17 December, 1999  
LD-1999-0062

**SUBJECT: RESPONSE TO NRC REQUEST FOR ADDITIONAL INFORMATION  
SUPPORTING TOPICAL REPORT CENPD-397-P REVIEW ACTIVITIES  
~~(ENCLOSURE 1 CONTAINS PROPRIETARY INFORMATION)~~**

**NON-PROPRIETARY RESPONSE TO NRC REQUEST FOR  
ADDITIONAL INFORMATION SUPPORTING TOPICAL REPORT  
CENPD-397-P REVIEW ACTIVITIES**

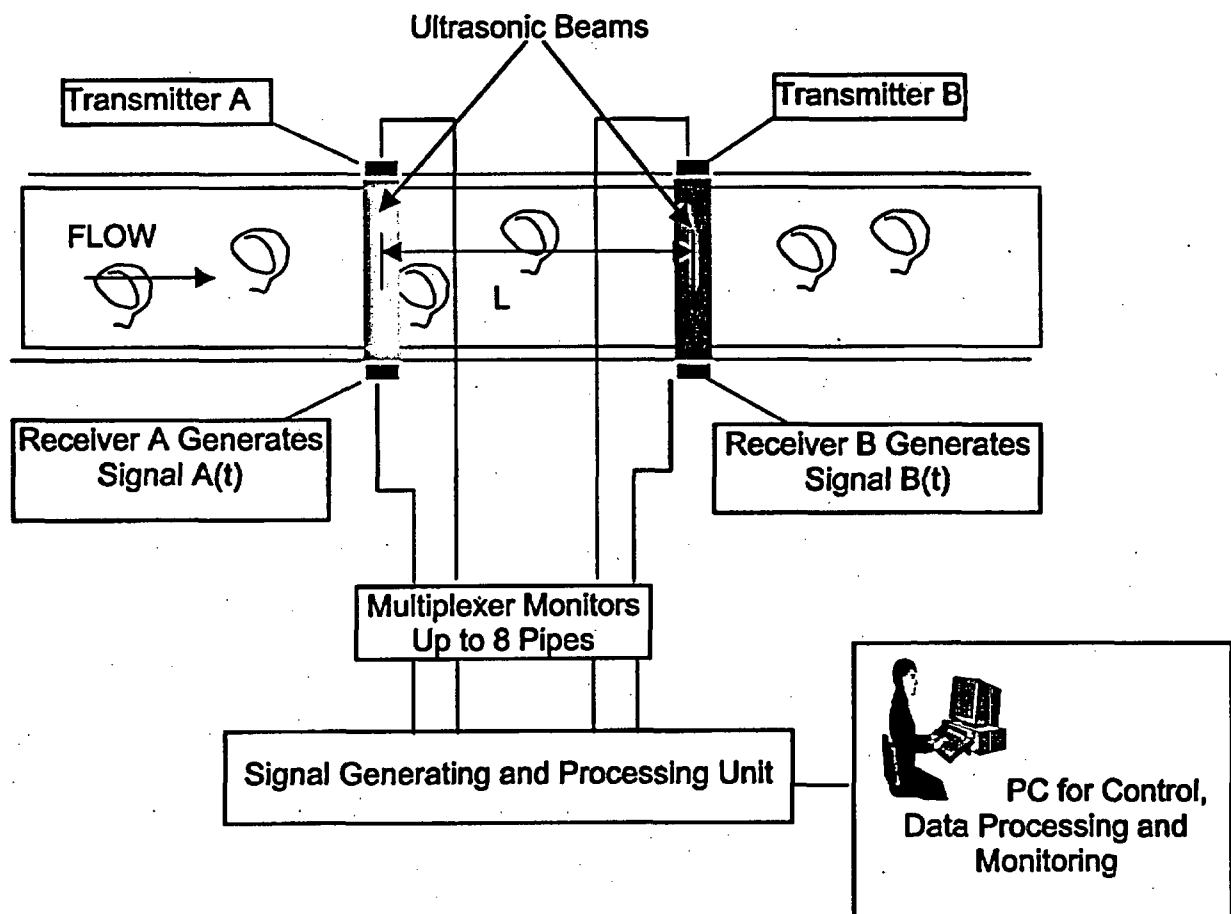
Section 2.2.2 defined cross-correlation as a "mathematical process for determining the displacement in time between similar curves." Please explain equations 2-9 and 2-10 and graphically identify the similar curves. Are the two signals A(t) and B(t +  $\tau$ ) through two different eddies or through the same eddy traveling between station A and station B?

It should be noted that the equations in Section 2.2.2 have been renumbered due to revisions in Section 2.1 of the topical report, CENPD-397-P, Rev. 00. Equation 2-9 is now Equation 2-5 and Equation 2-10 is now Equation 2-6.

The underlying principle of the cross-correlation technique is illustrated in the following figure:
